Well Name: SAN ISIDRO 16	Well Location: T20N / R3W / SEC 16 / NWSE / 35.961797 / -107.155495	County or Parish/State: SANDOVAL / NM
Well Number: 10	Type of Well: OIL WELL	Allottee or Tribe Name:
Lease Number: NMNM105185	Unit or CA Name:	Unit or CA Number:
US Well Number: 3004320719	Well Status: Oil Well Shut In	Operator: FINLEY RESOURCES INCORPORATED

Type of Action: Plug and Abandonment

Attachment to Notice of Intention to Plug and Abandon

Well: San Isidro 16 10 (API#30-043-20719)

Wellbore after completion of march 20, 2010

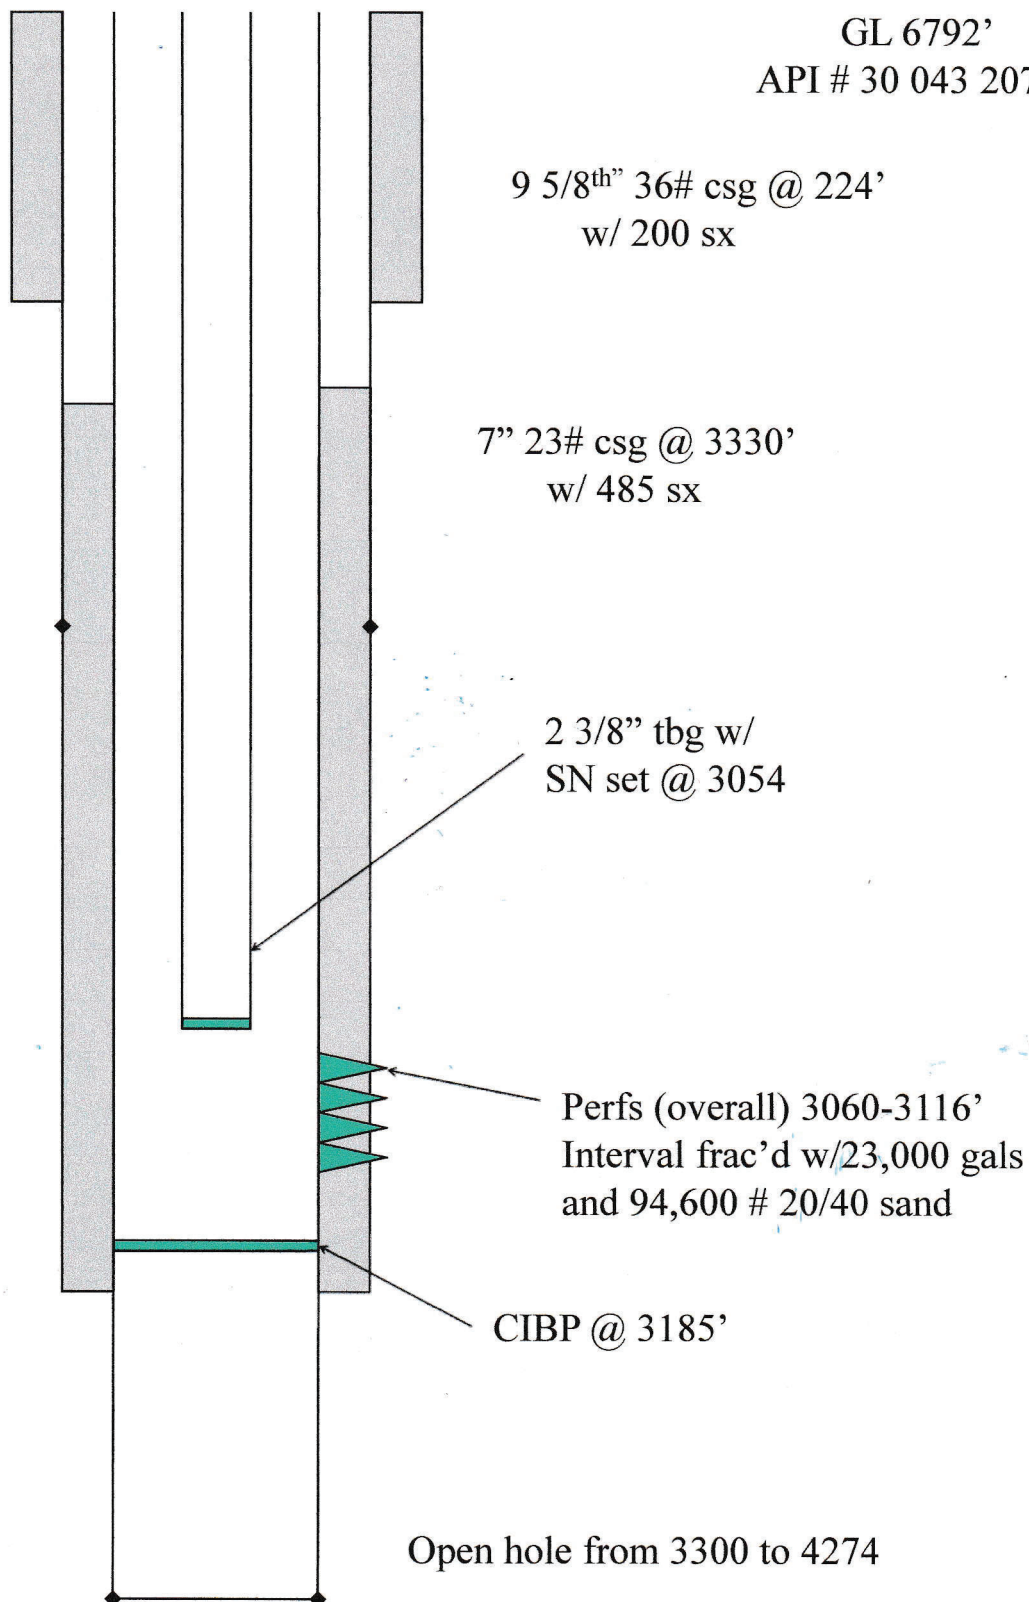
- a. Adjust plug #4 (Step 11 #1) to cover BLM Cliff House formation top pick @ 2130'. (Estimated minimum 25sxs class C cement covering 2030' – 2180')
 - b. Add plug to cover BLM La Ventana formation top pick @ 1790'. (Estimated minimum 25sxs class C cement covering 1690' – 1840')

- c. Add plug to cover BLM Lower Chacra formation top pick @ 1410'. (Estimated minimum 25sxs class C cement covering 1310' to 1460')
 - d. Adjust plug #5 (Step 11 #2) to cover BLM Picture Cliff formation top pick @ 690'. (Estimated minimum 25sxs class C cement covering 590' - 740')

- e. Add plug to cover BLM Fruitland and Ojo Alamo formation picks @ 490' and 362', respectively. (Estimated minimum 38sxs class C cement covering 312' – 540')

- f. Adjust Surface Shoe and Surface Plugs (Steps 12 and 13) to cover from 274' to surface. (Estimated minimum 46 sxs)

- Vertical wellbore - all fm. tops are TVD.
 - Note that all depths include 13' KB.
 - The cement type is not not completely clear. "C" cement is mentioned in some plug descriptions and not mentioned in others.
 -The bottom 3 plugs, to and including the plug over the top of the CICR, are acceptable. All the plugs above these 3 have been moved and others added according to the BLM Geologist's picks for formation tops. In addition, the minimum plug volume from here up is 25 sacks/plug.

- Set a plug to cover the Cliff House formation (Mesa Verde Group top) from 2030' to 2180'.
 -Set a plug to cover the La Ventana top from 1690' to 1840'.
 -Set a plug to cover the Lower Chacra from 1310' to 1460'.
 -Set a plug to cover the Pictured Cliffs from 580' to 740'.

- The Ojo Alamo must be completely covered. Set a plug from 262' to 540'.
 - Set a surface plug from 274' to the surface.
 -Please note that a CBL is to be performed. Each of the modified plugs may require squeezing depending on the CBL results.
 -If the operator wants to set a plug over another formation the minimum volume is 25 sacks.

Created By	Condition	Condition Date
mkuehling	Follow BLM coas with added - first plug should run 100 feet of cement tag first plug - notify nmocd with results of tag - tag any plug thereafter if pressure test is a fail - add upper chacra plug from 1130 to 980 - Notify NMOCD 24 hours prior to moving on - when notifying - state at that time what type of cement you will be using and who will be running cement	11/13/2023
